Device	TC1766
Marking/Step	EES-BB, ES-BB, BB
Package	PG-LQFP-176-2

01740AERRA

This Errata Sheet describes the deviations from the current user documentation.

Figure 2 Timing concerning equidistant multiple timers

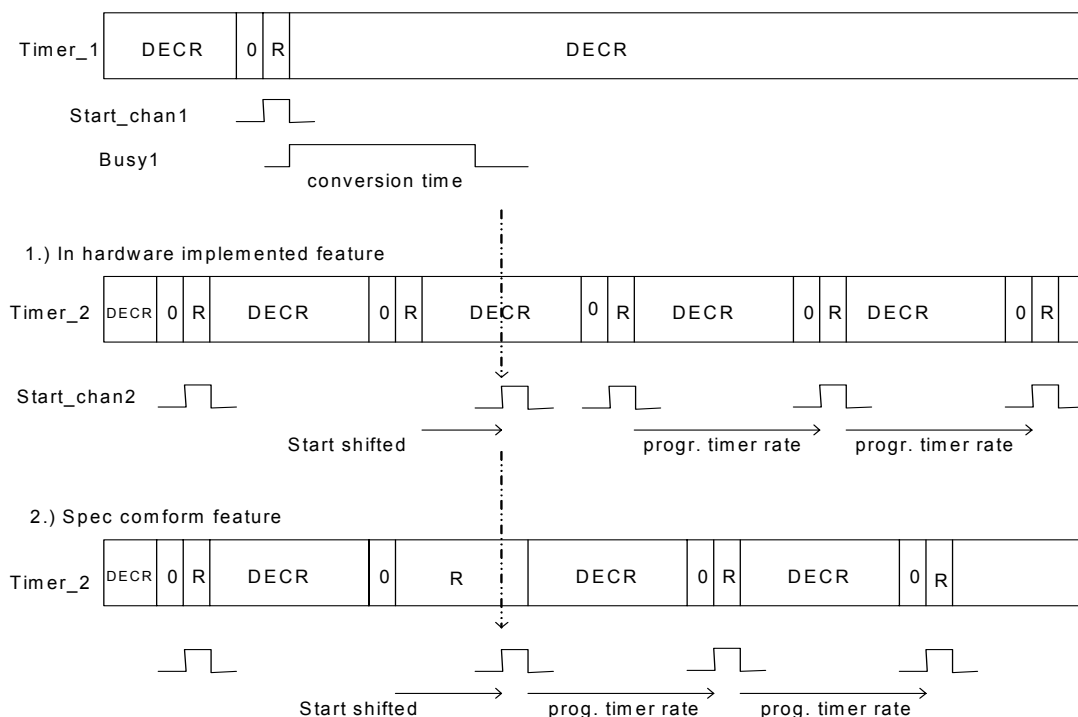
The correct behavior would be a reload when the requested conversion (of `channel_2`) is started.

Therefore the start of conversion for `channel_2` is delayed by maximum one conversion-time. After this delay it will be continued with equidistant conversion-starts. Please refer to the following figure.

Figure 5 **Critical transmission**

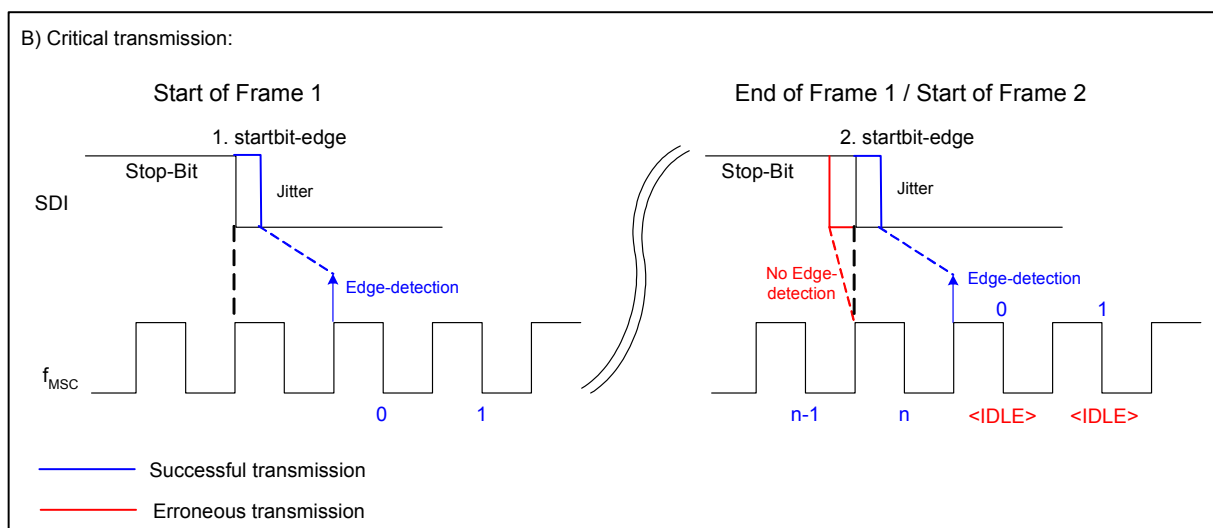
If the high-low edge of the start-bit in the first frame is just not detected by the near clock-edge (**Figure 5** - left) and the start-bit edge of the second frame is jittering to cycle $n-1$ (**Figure 5** - right, red coloured), then an erroneous transmission will take place. In this case the state-machine switches to IDLE after the last state n and wakes up on the next falling edge that may be a data-bit recognized as a start-bit. If the start-bit of the second frame is jittering to cycle n (**Figure 5** - right, blue colored), then the state-machine will not switch to IDLE but will start receiving the next frame correctly.

Figure 10 Current accuracy range

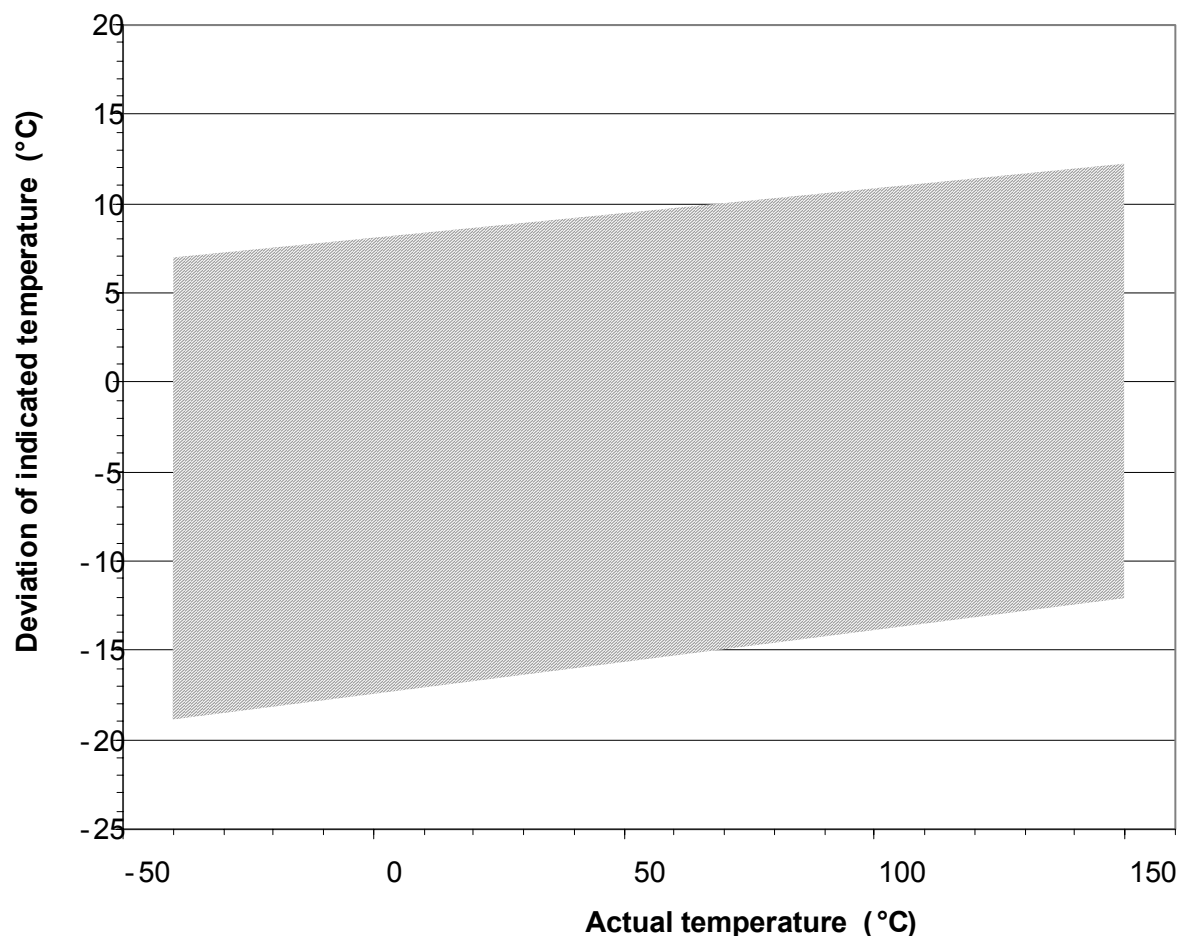
The accuracy of the DTS deviates from the values specified in the Data Sheet. The formulas available on the specification are as follows:

The deviation using these formulas is:

- +/-12°C at $T_j = 150^{\circ}\text{C}$
- +9/-17°C at $T_j = 25^{\circ}\text{C}$
- +7/-19°C at $T_j = -40^{\circ}\text{C}$

Figure 11 Exemplary power-up/down sequence

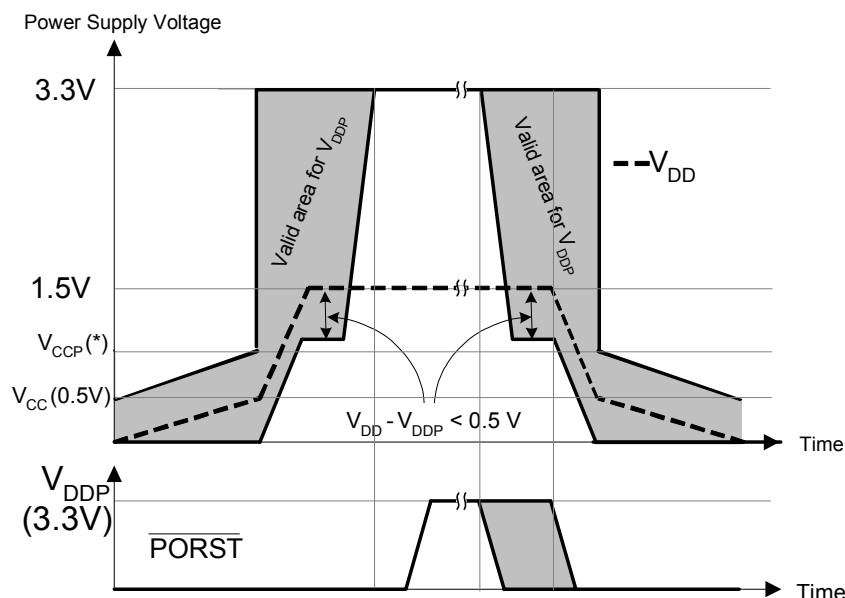
As per Data Sheet, $V_{DD} - V_{DDP} < 0.5\text{ V}$ has to be valid at any time in order to avoid increased latch-up risk. The figure below shows the possible V_{DDP} values as shaded region for an exemplary V_{DD} ramp. Moreover, the following rules apply:

- All analog voltages (V_{DDOSC3} , V_{DDM} , V_{DDMF} , V_{DDFL3}) must also follow V_{DDP} power-up/down sequence.
- V_{DDAF} , V_{DDOSC} must follow V_{DD} power-up/down sequence.
- The absolute value of the maximum allowed deviation between any two supplies is 0.5 V while the 1.5V supplies are below their specified operating conditions.
